VALUE ENGINEERING CHANGE PROPOSAL MISSOURI DEPARTMENT OF TRANSPORTATION

Contract ID 101217-401 Job No. J4I-1574, J4I-1679 & J4I-2155

County Jackson I-70 Original Bid Cost \$10,938,325.16

Rte's 70, 470 & 435 – VE Narrative

Typical Section (both directions)

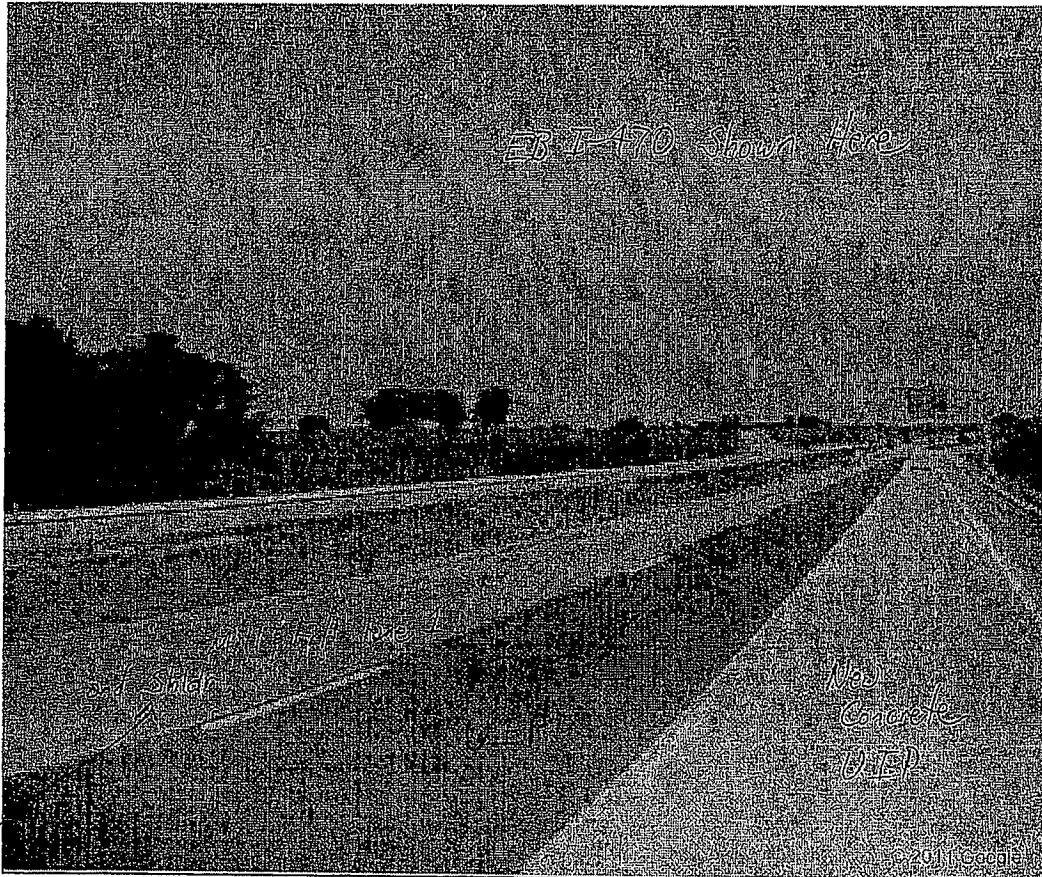
3/4" MILL & UBAWS FILL - 16' WIDE
1.31 MILES = 6,916.8 FT WESTBOUND/EASTBOUND = 13,833.6
MILL/UBAWS = $\frac{13,833.6 \times 16}{9} = 24,593.1 \text{ SY}$ $\times \$3.10 = \$76,238.61$

1 3/4" MILL & SPI25B FILL - 14' WIDE
 $\frac{13,833.6 \times 14 \times 1.75}{12} = 1046.06 \text{ CY} \times 1.953 = 2042.96 \text{ TONS}$
27 = \$170,709.70

Savings = \$94,471.89
MODOT 75% = \$70,853.32
Contractor 25% = \$23,617.77

WB I-470
Begin Mill & Fill
Log mile 7.89

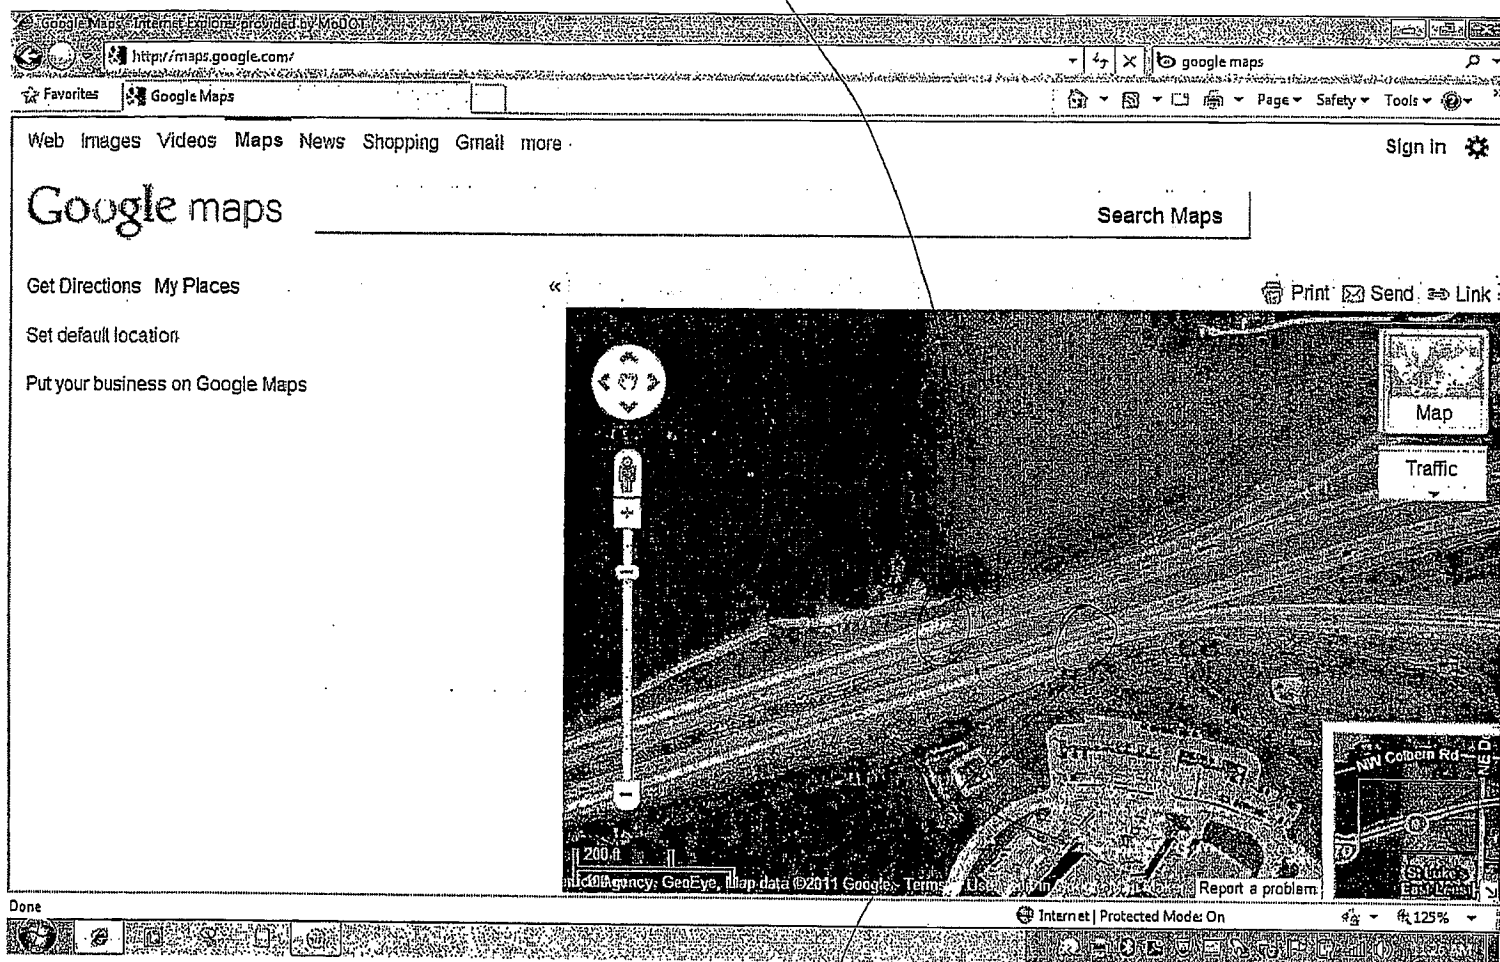
EB I-470 — end mill & fill
log mile 9.00

I-470 WB
end mill & fill log mile 9.20

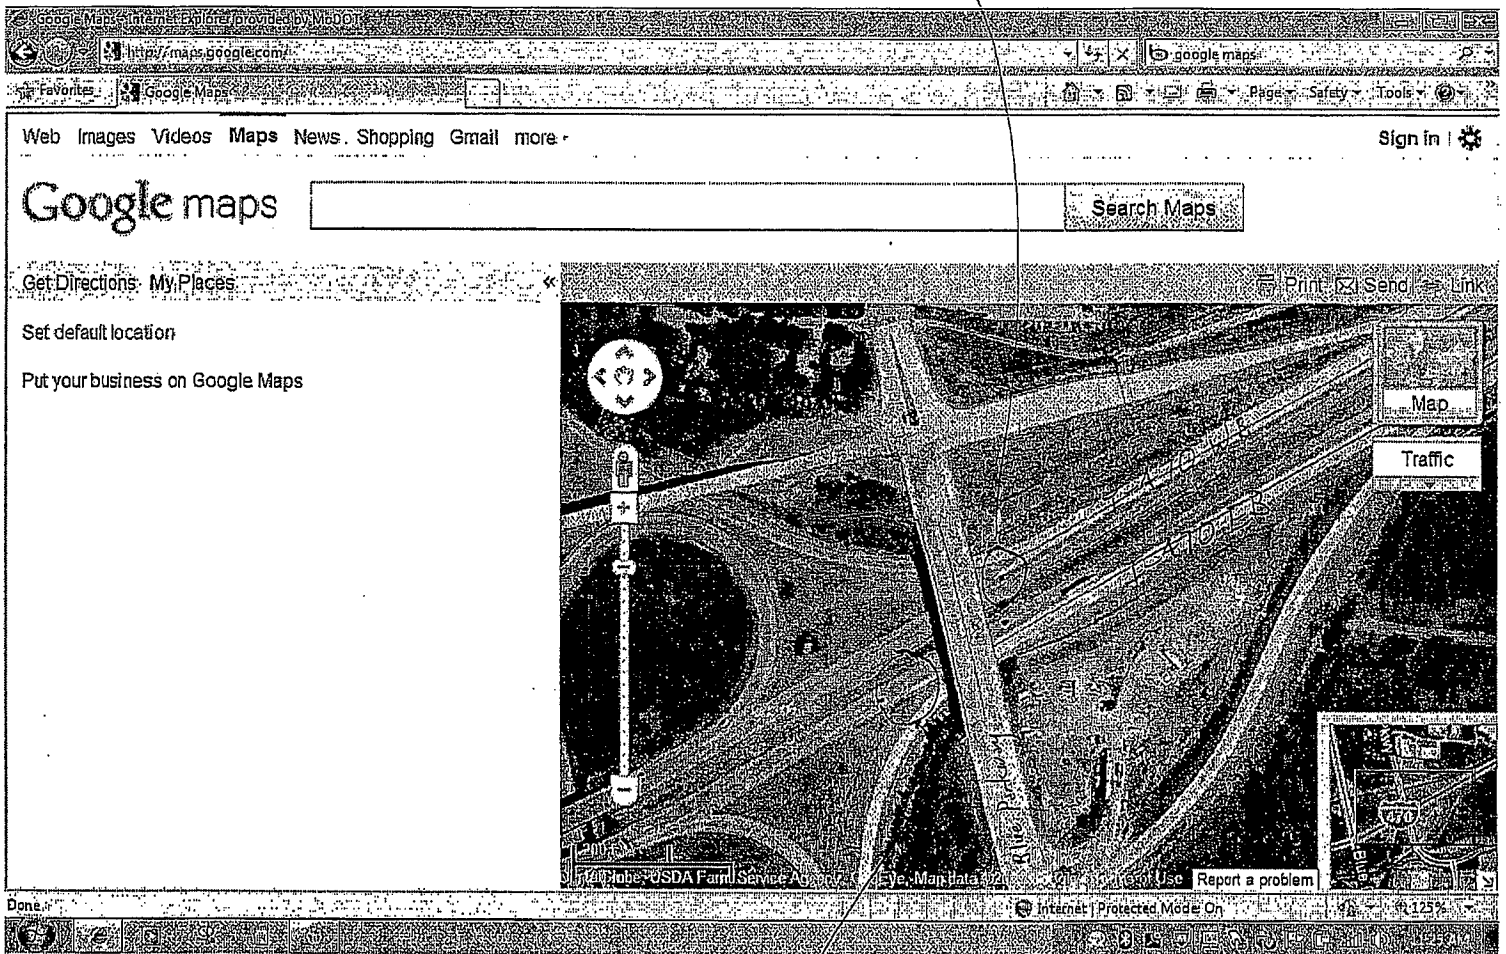
I-470 EB
begin mill & fill
log mile 7.69

~1.4 mi scaled distance

$9.00 - 7.69 = 1.31 \text{ mi (cold mill)}$
